ADDENDUM NO. 1

Northeast Metro Intermediate School District - ISD 916

Wide Area Network RFP, published 12/16/2015

January 4, 2016

1 ELECTRICAL SITE PLAN
1" = 50'

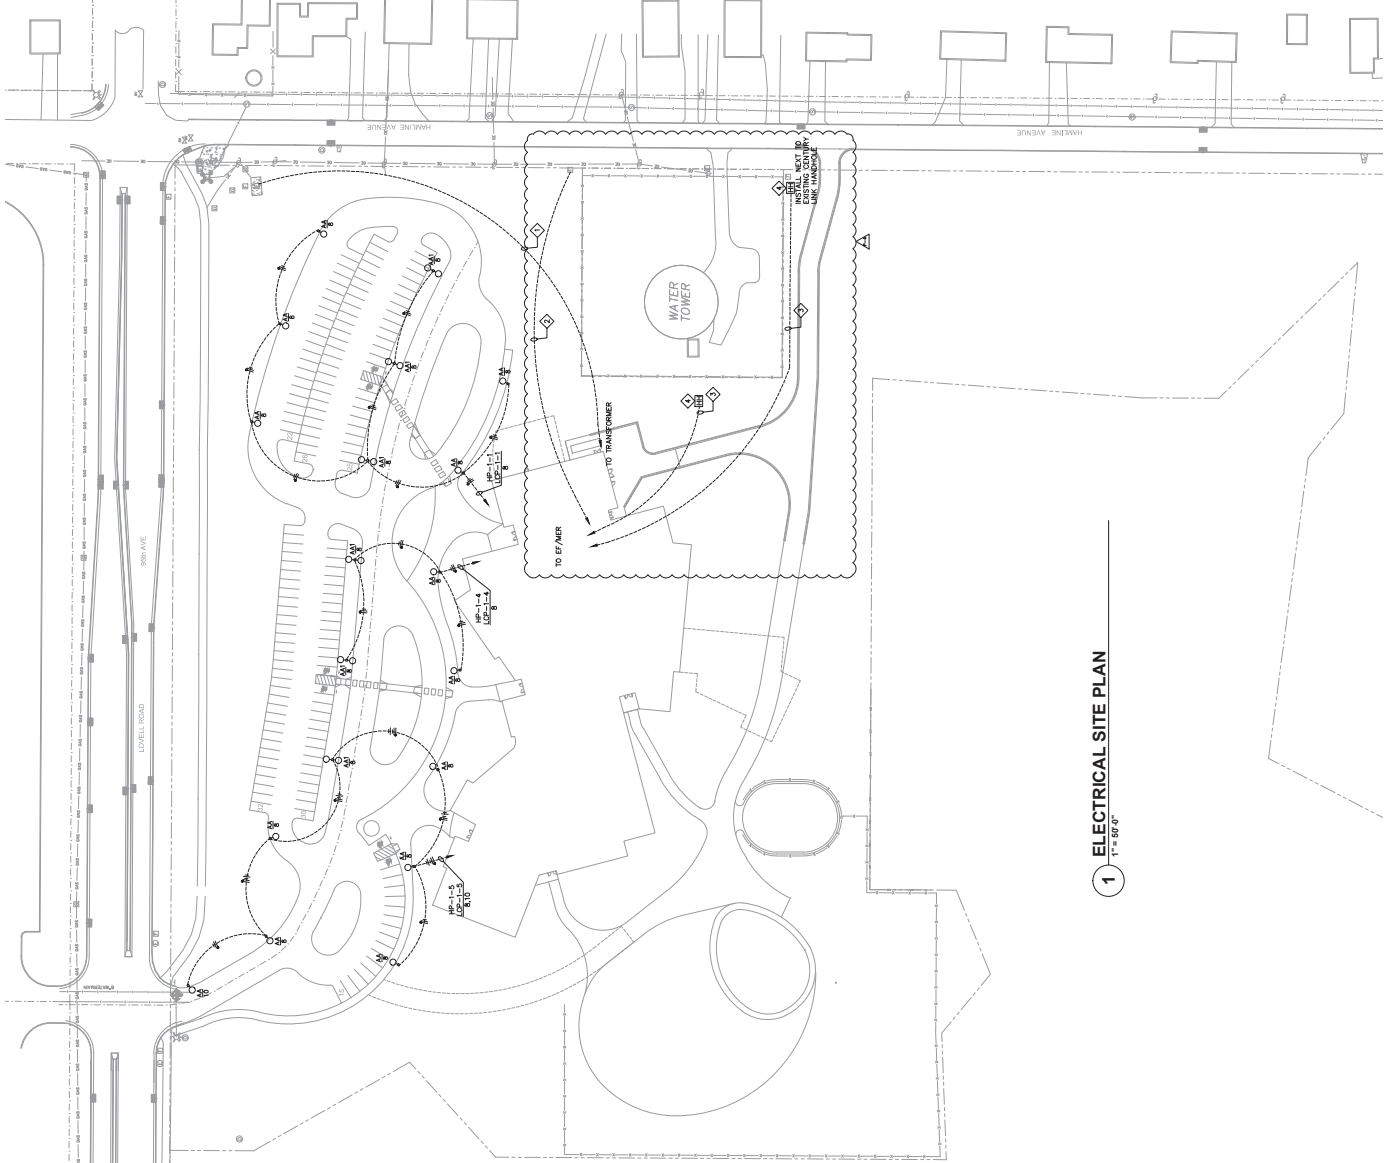
6. What are the lengths of outside conduit runs from hand holes at the property lines to the building entrance facilities at Pankalo, Karner Blue and Capitol View? **Answer:** the construction plans for Capitol View are not yet complete. The full site plans for the Pankalo site and Karner Blue site are the final two pages of this addendum.
